DEVELOPMENT REVIEW BOARD  
**SUPPLEMENTAL SUBMITTAL**

PROJECT NO. 2020-004475  
Application No. SI-2021-00254

SUBMITTAL  
DESCRIPTION: Dental office for Pino Periodontics. This submittal includes the responses to all the staff comments.

**RE: Pino Periodontics dental office development at 7413 Holly Ave NE.**

9 | hcp ramp detail A001 1/4"=1'-0"

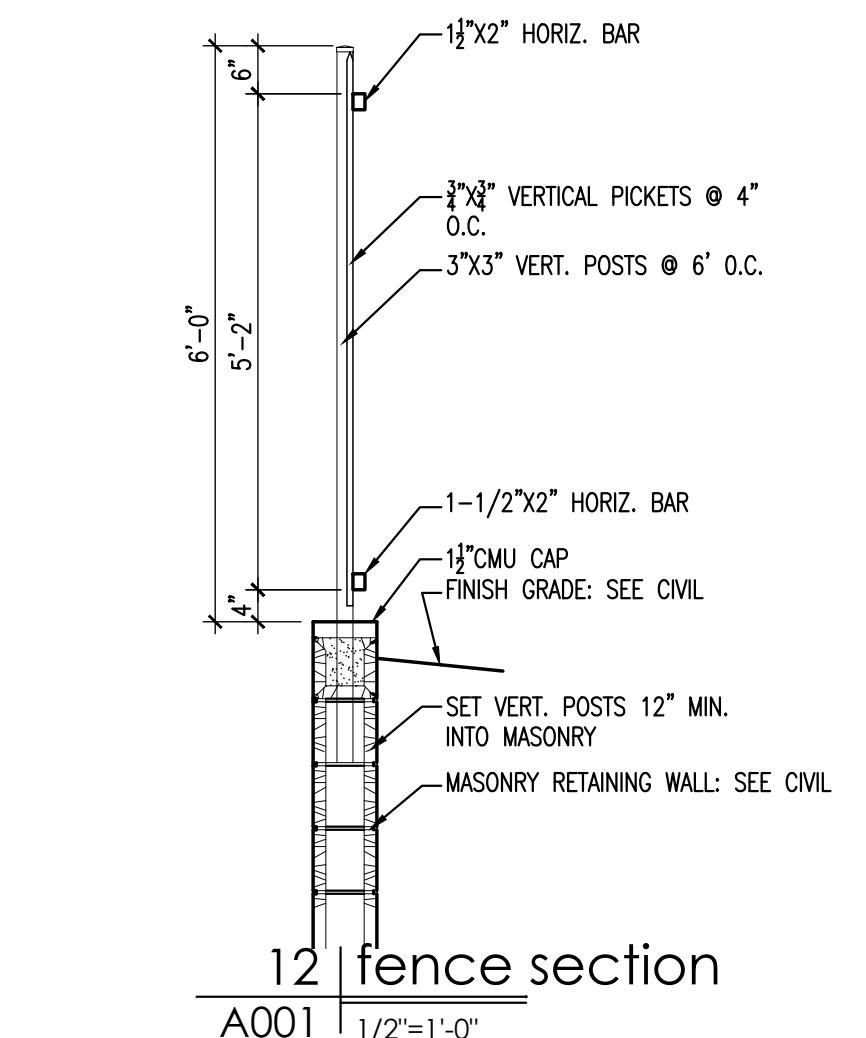
7. **6' pathway to Hcp spaces:** the sidewalk at the accessible route is 8'-6" wide and 6'10" wide leading to building entrance.
8. **Hcp Ramps:** The handicap ramps have been changed to a linear configuration that meets the requirement.
9. **TIS.** TIS form has been sent to Matt Grush for sign off.
10. **Cross section of Roadway:** Cross section of roadway has been added to the site plan and required references have been added.

8 | bike rack detail A001 1/2"=1'-0"

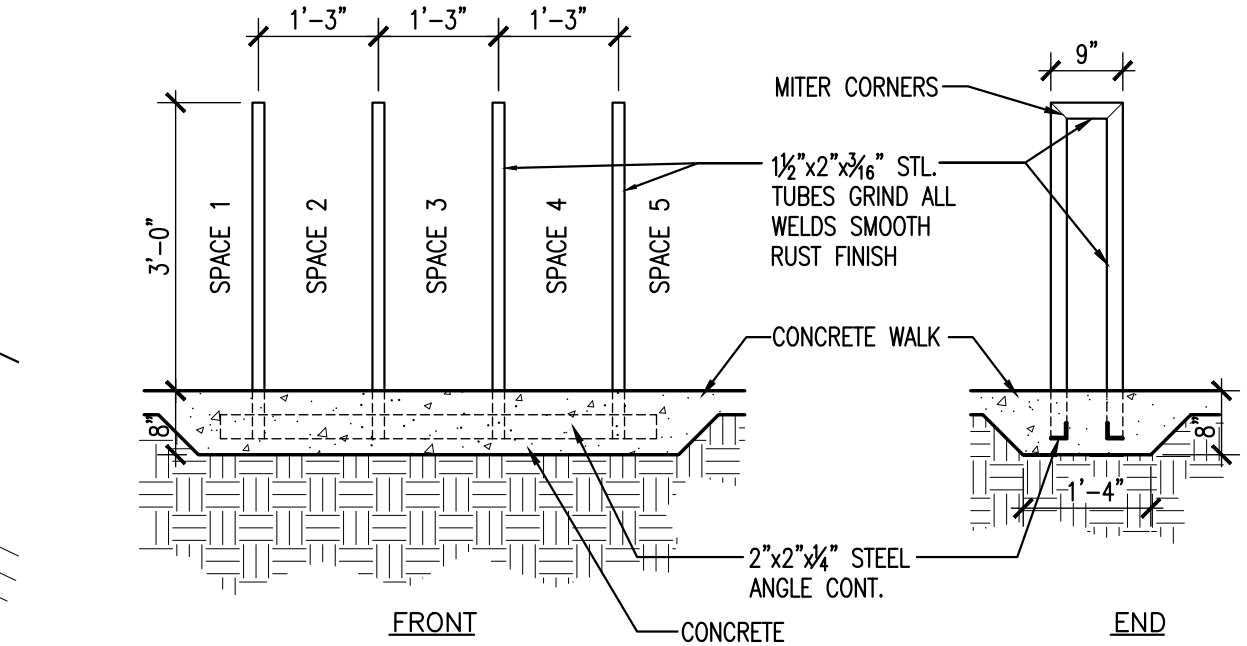
5. **Bike Rack:** a bike rack is now shown on the site plan and referred to detail 8/A001
6. **Hcp Parking signs:** Handicap parking signs are shown at each of the four hcp parking spaces and referred to detail 5/A001.

5 | hcp sign detail A001 1/2"=1'-0"

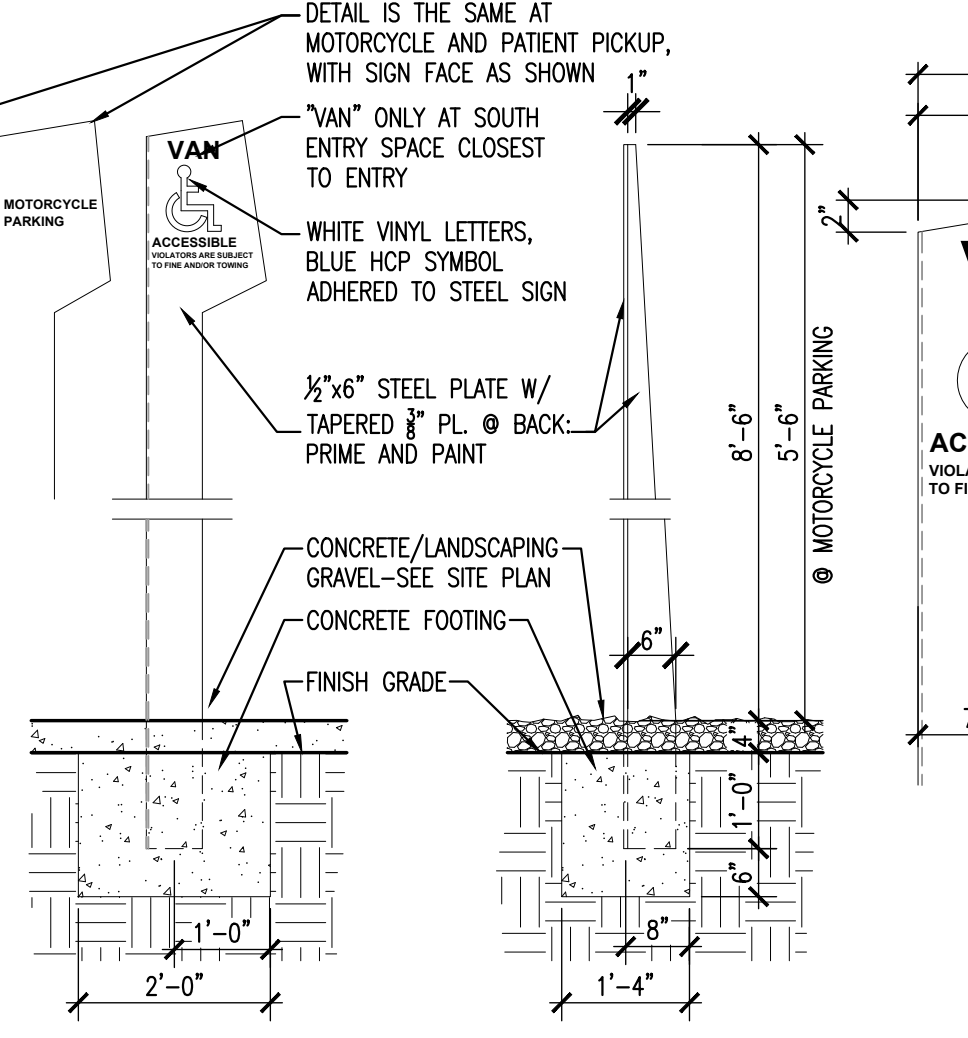
4. **Motorcycle Parking:** The motorcycle spaces have "MOTORCYCLE PARKING" shown to be painted on the parking spaces and vertical signs are also shown at the front of the spaces. Detail 5/A001 refers to the signs.

7 | curb & gutter detail A001 1"=1'-0"

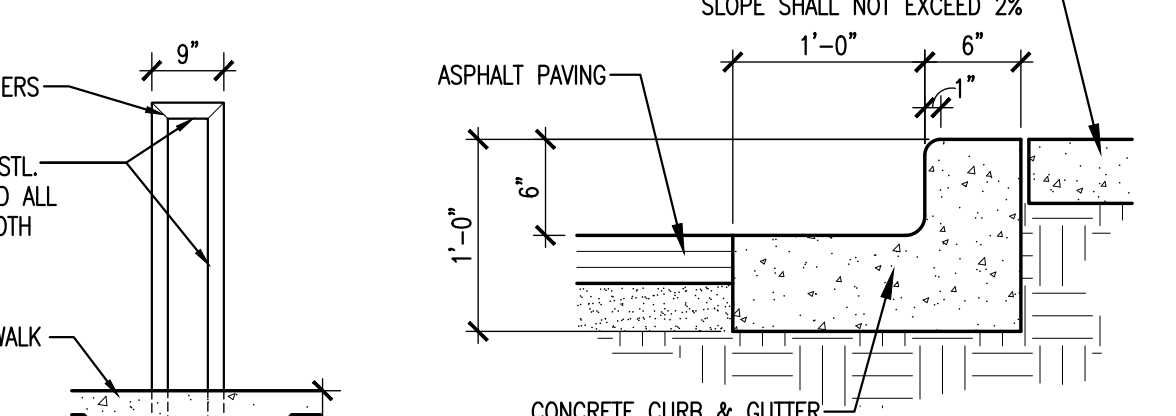
3. **Curbs and sidewalk cross slope:** Curb and gutter locations are indicated on the site plan. Detail 7/A001 shows the curb and a note has been added "At sidewalk locations cross slope shall not exceed 2%." Also, a note has been added in three locations on the site plan "SIDEWALK NOTE: CROSS SLOPE AT SIDEWALKS SHALL NOT EXCEED 2% GRADE, TYP."

7413 HOLLY AVENUE NE FOR ROADWAY SECTION SEE 13 A001 site plan A001 1"=20'

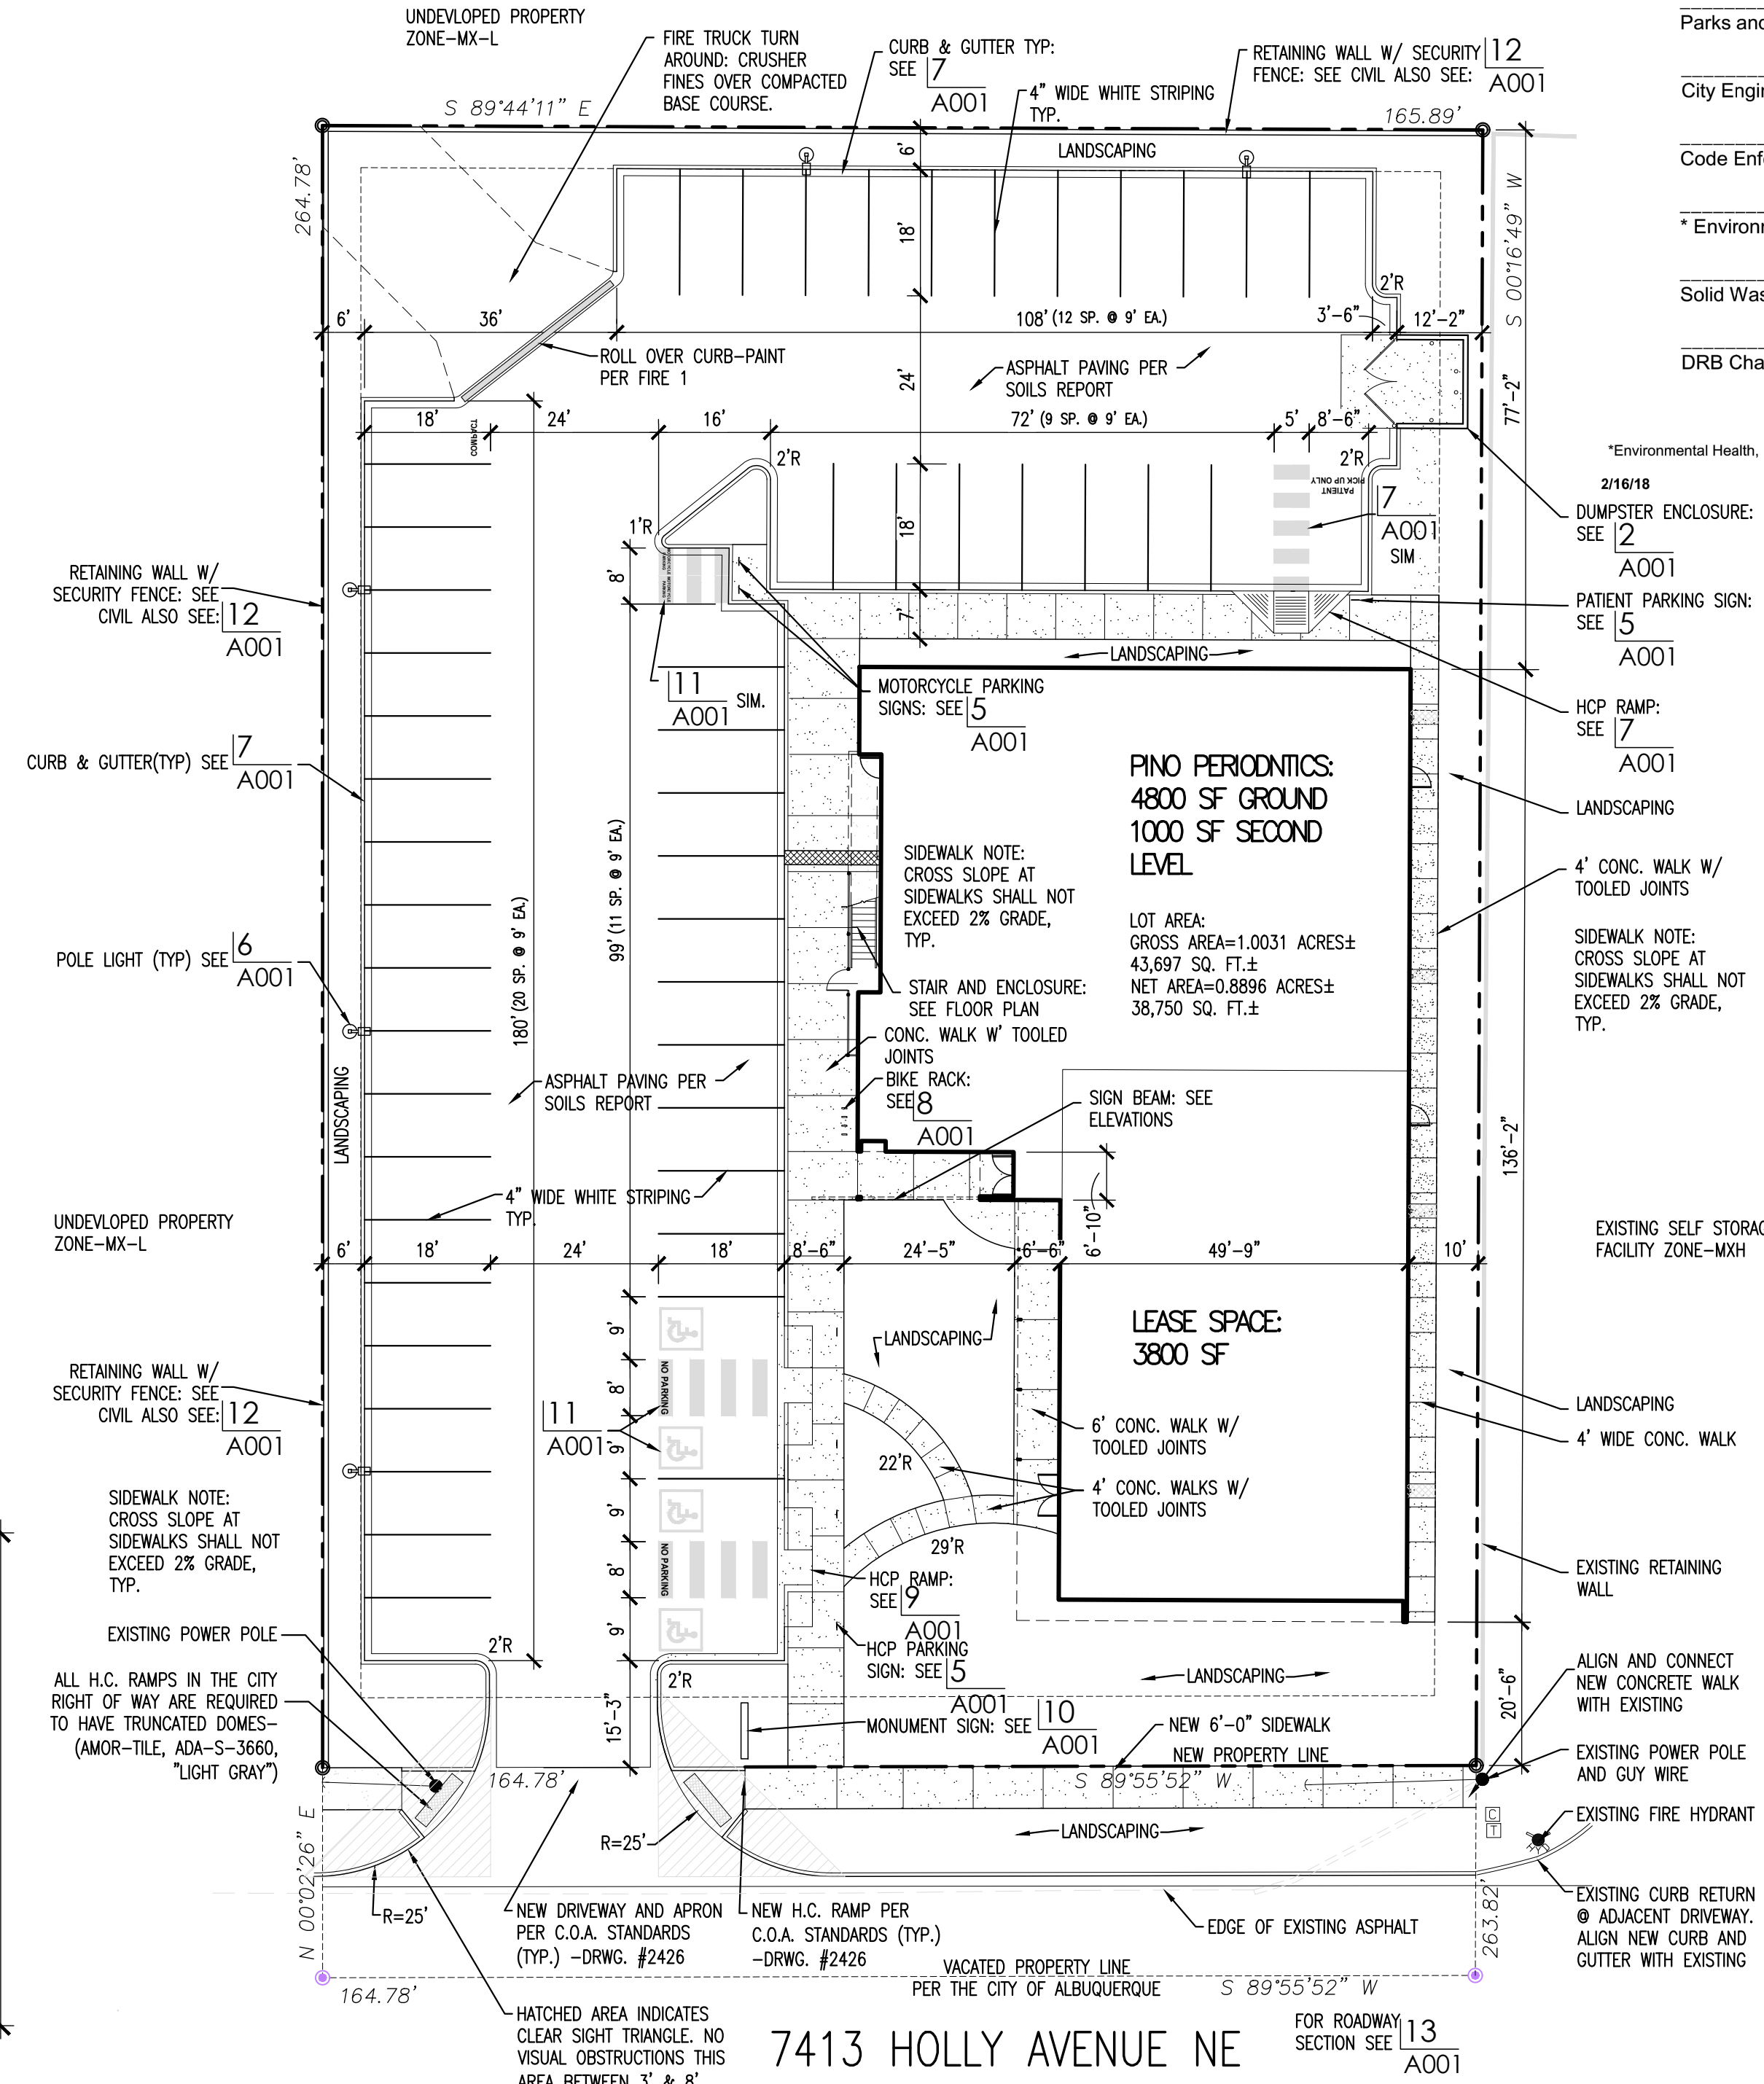
1. **Fire Marshal approved site plan:** Fire Marshal approved site plan is attached here.
2. **Parking calculations:** The parking calculations were shown on the FIRE 1 Site plan and have been added to the architectural site plan, attached here.

FIRE 1 SITE PLAN  
CODE DATA  
revisions

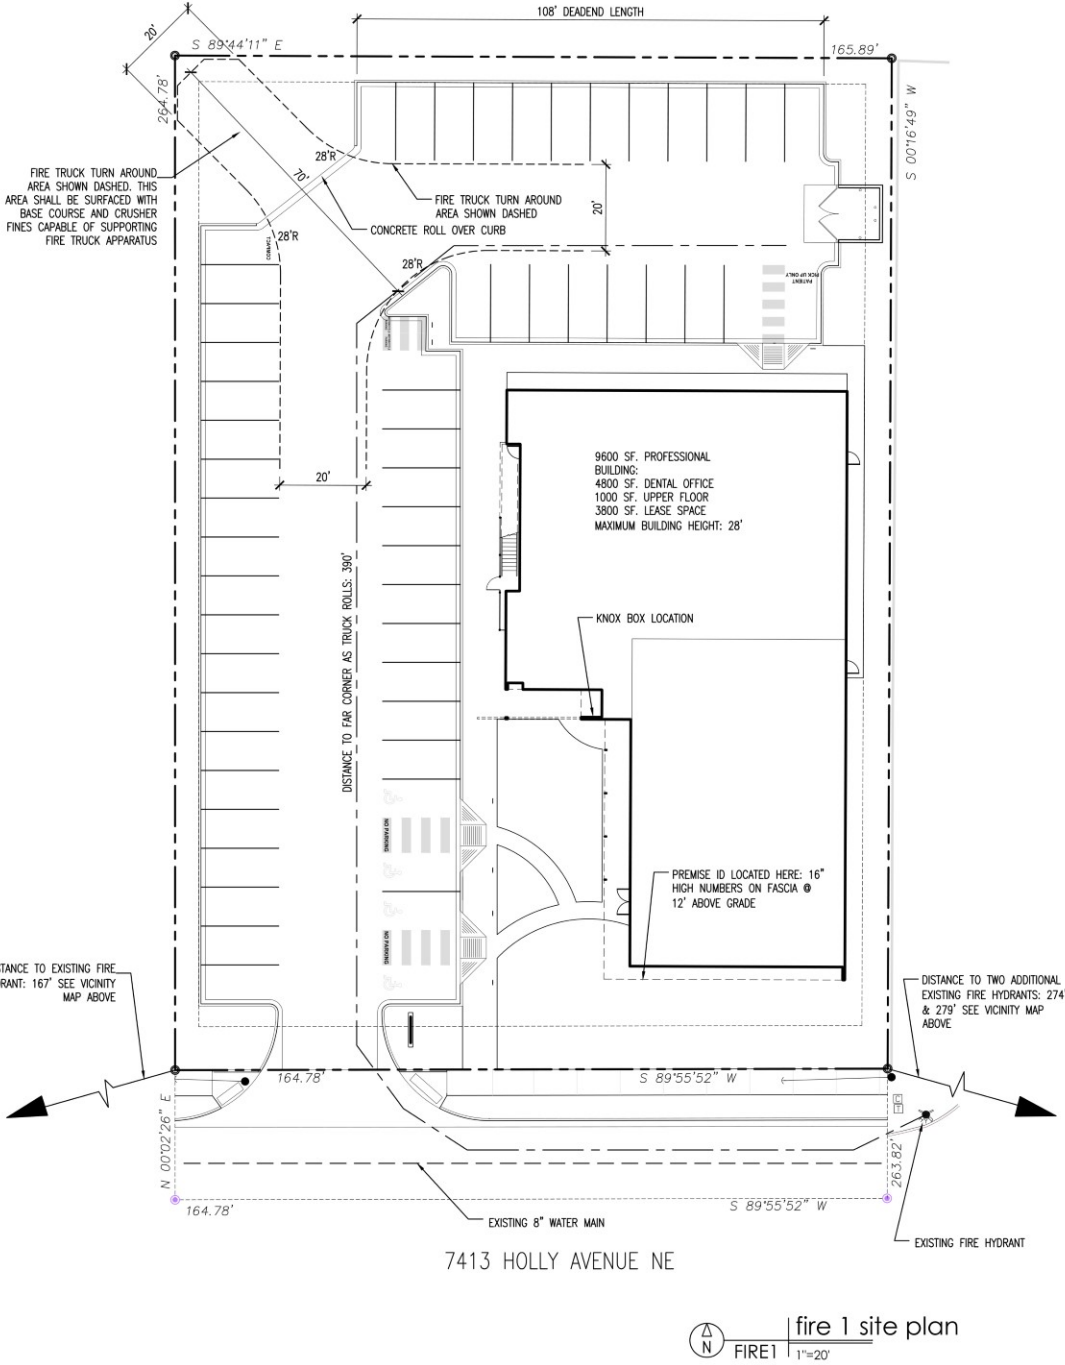
1. **Parking calculations:** The parking calculations were provided on the Fire 1 site plan, which has been approved and attached here.
2. **Zoning:** The zoning has been changed to MX-L by EPC. The Official Notice of Decision is attached here.
3. **Landscape Buffer:** The front (South) side of the site which abuts Holly avenue is screened by a landscape buffer 20'-6" wide at the building location and 15'-3" adjacent to the parking lot, both are in excess of the requirement. Landscape in these areas meets the minimum requirement for planting as described in the IDO. Screening for headlights is a non-issue as the parking spaces are parallel to the street.
4. **Side and Rear lot edges:** The side and rear lot lines do not abut a public street therefore the requirement does not apply. However a 6' landscape buffer has been provided at side and rear property lines.
